3 LOT FINAL 6-10-87 86-78 -
App. 2 Lot Preliminary
CBC Management Subdivision 5 lots

TOWN OF NEW WINDSOR
PLANNING BOARD
REVIEW COMMENTS

PROJECT NAME: C.B.C. Management Subdivision
PROJECT LOCATION: Twin Arch Road (South of Route 207)
NW #: 86-78
27 May 1987

DRAWING NUMBER: 86-576
Rev. June 9, 1984

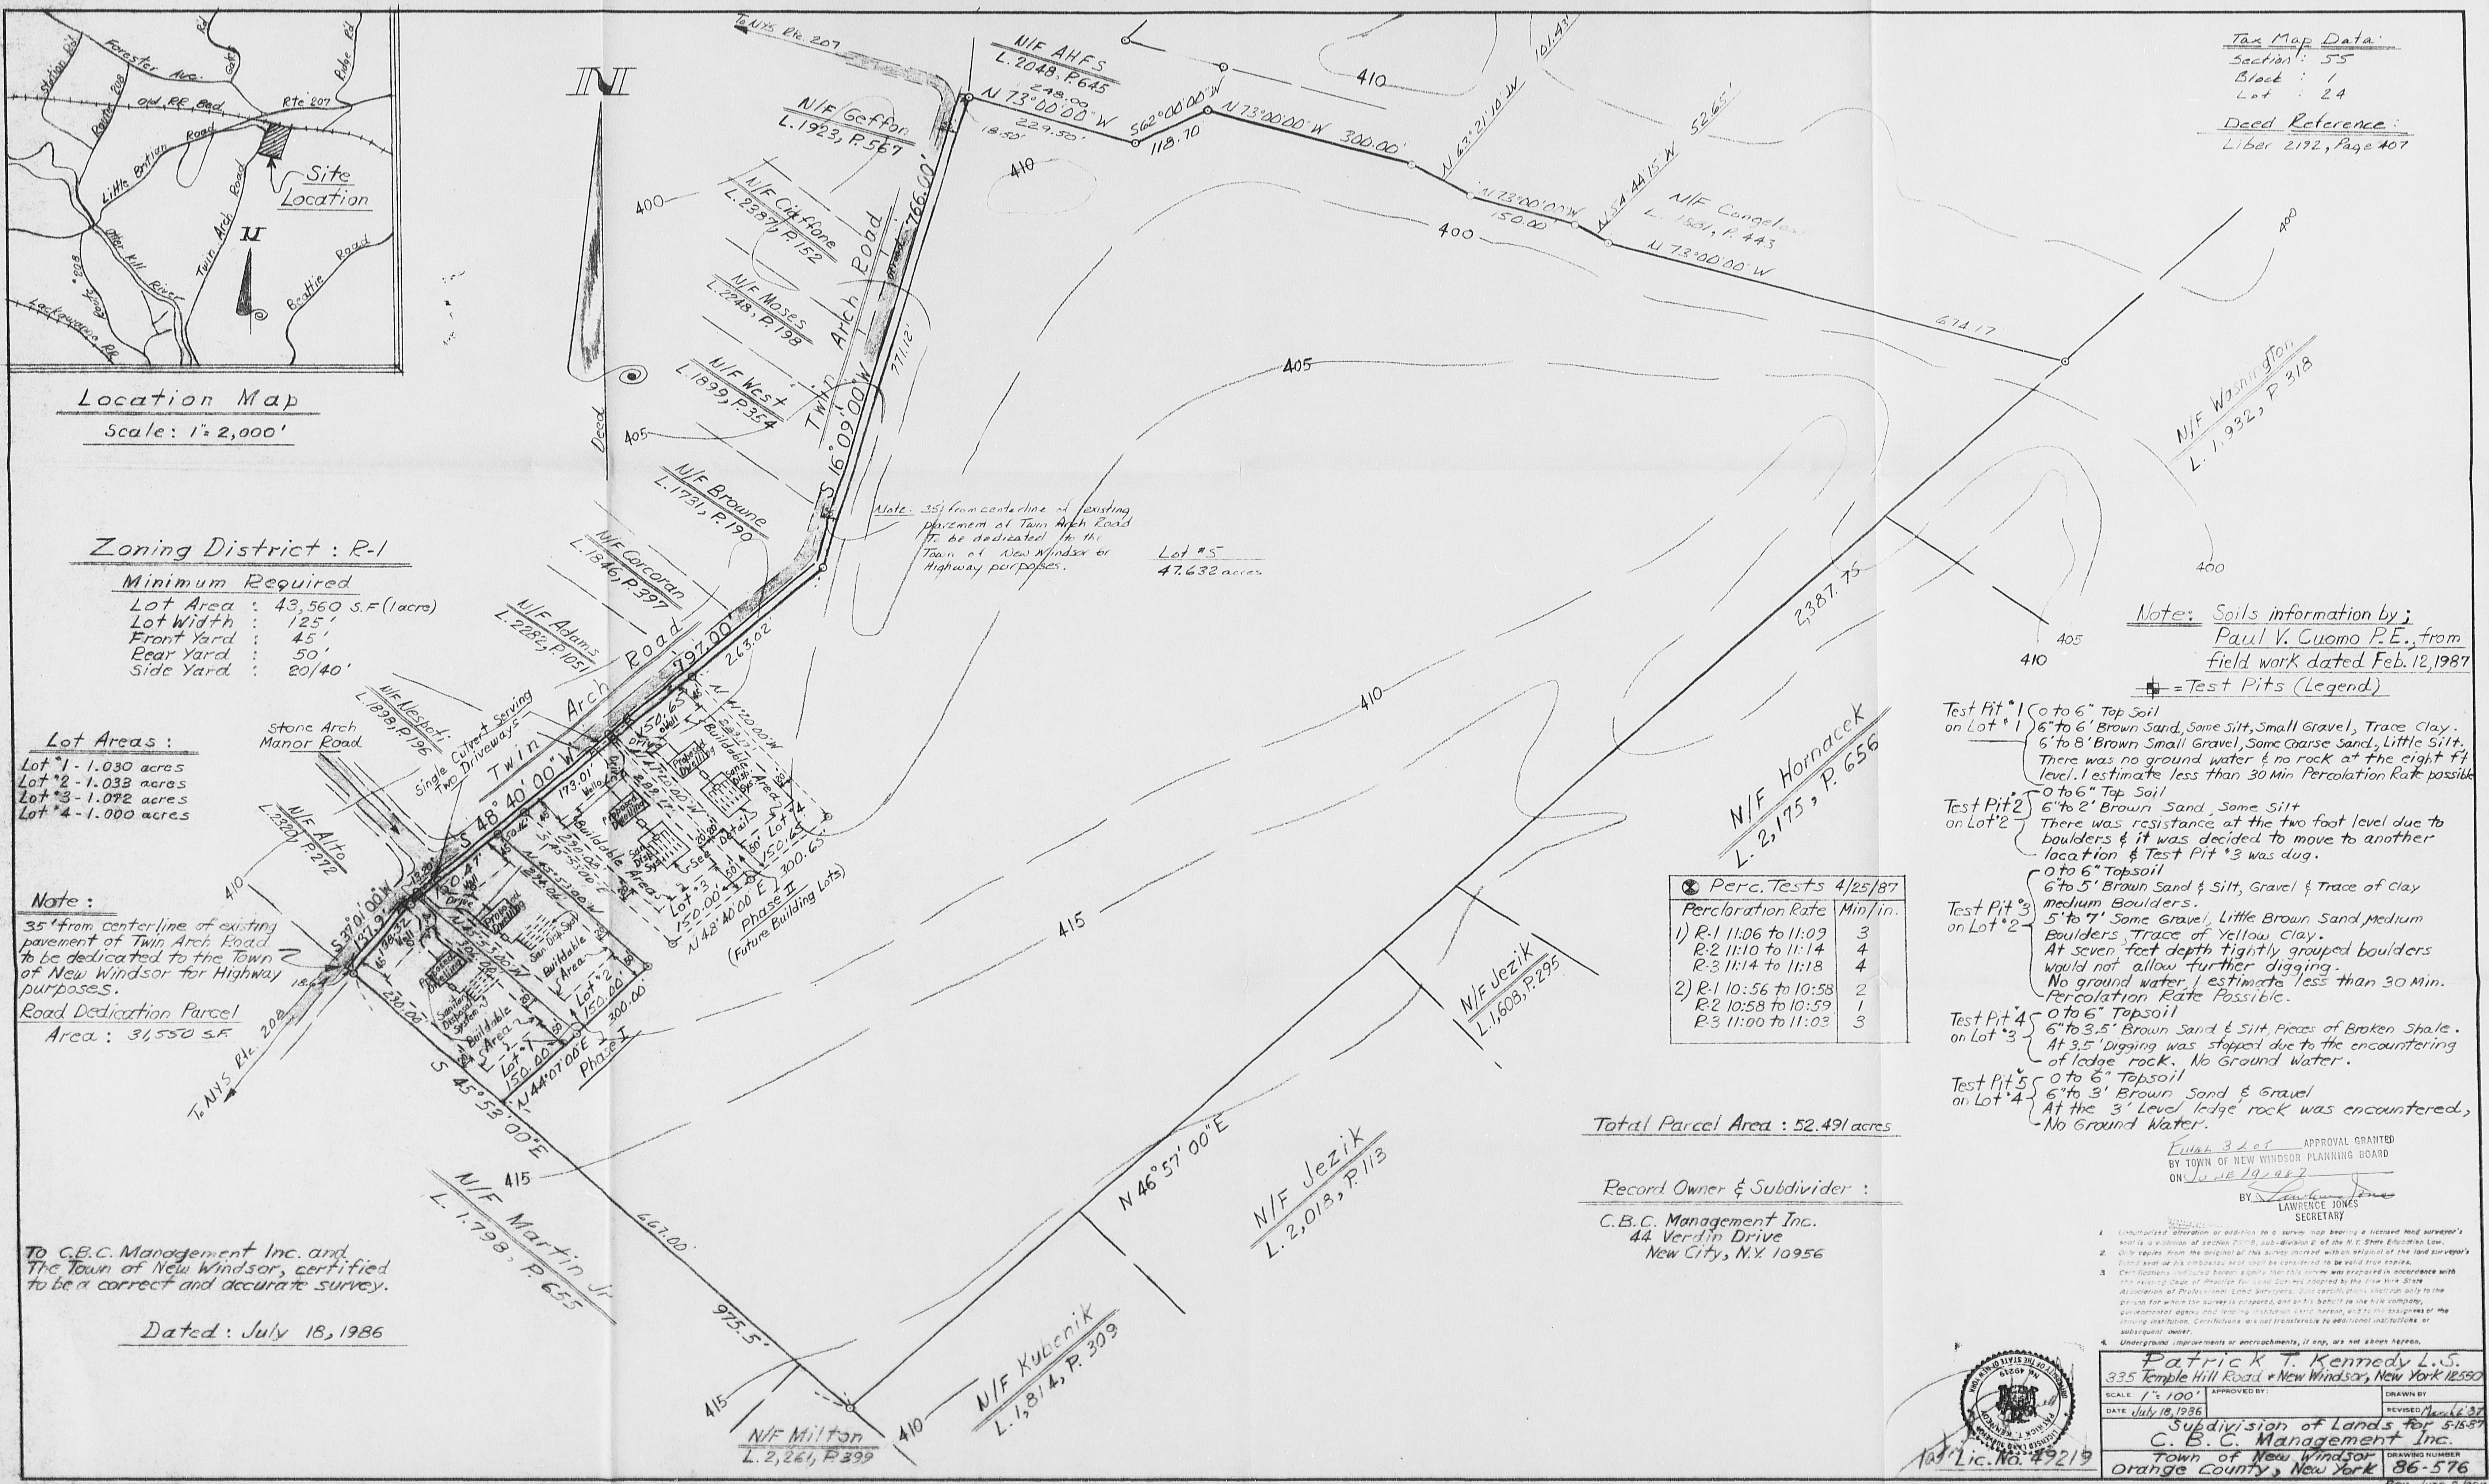
2). The Subdivision Plan indicates the location of Deep Tests; however, the location of Deep Test No. 3 is not indicated.

3). The information on the Plan includes "estimates" of what perc rates are "possible"; such information is unacceptable and actual percolation testing must be performed.

4). The Plan implies that the sanitary disposal system for Lot No. 2 will be a conventional system; however, Test Pit No. 2 indicates bedrock at 2' depth. Construction of a conventional system under such conditions is not acceptable.

5). The previous comments of the Engineer requested that the plan locate Stone Arch Manor Road such that the location of the proposed subdivision lots would be more clear; the revised plan does not appear to do so. In light of the numerous rock outcroppings and the inability to evaluate the property in the area of the proposed four building lots, I cannot make a positive recommendation at this time.

- 1). The Applicant proposes a five (5) lot subdivision of a 52.5 +/- acre parcel.
- 2). The Subdivision Plan does not indicate results from Percolation testing, nor any "reserved area" for the sanitary system. Proposed well locations must also be shown. Verification of spacing between sanitary and wells (both existing and proposed) must be indicated.

- 3). A cursory field review indicates numerous rock outcroppings; deep tests should be performed in proposed sanitary disposal areas.
- 4). Plan should make location of the site in the field more clear; locate Stone Arch Manor Road and (if possible) opposite property owners. Also, identification of the "private road" is requested.

- 5). The Board may wish to discuss the purpose of the 50' strip located between Lots 2 and 3 as well as the future plans for lot #5.
- 6). Single culvert pipes should be provided for the double driveway entrances off Twin Arch Road, if required by existing shoulder drainage conditions.

Submitted map does not indicate systems
for waste disposals.

35' from centerline of existing pavement of Twin Arch Road to be dedicated to the Town of New Windsor for Highway purposes.

Perc. Tests 4/25/87		
Percolation Rate	Min/in.	
1) R-1 11:06 to 11:09	3	
R-2 11:10 to 11:14	4	
R-3 11:14 to 11:18	4	
2) R-1 10:56 to 10:58	2	
R-2 10:58 to 10:59	1	
R-3 11:00 to 11:03	3
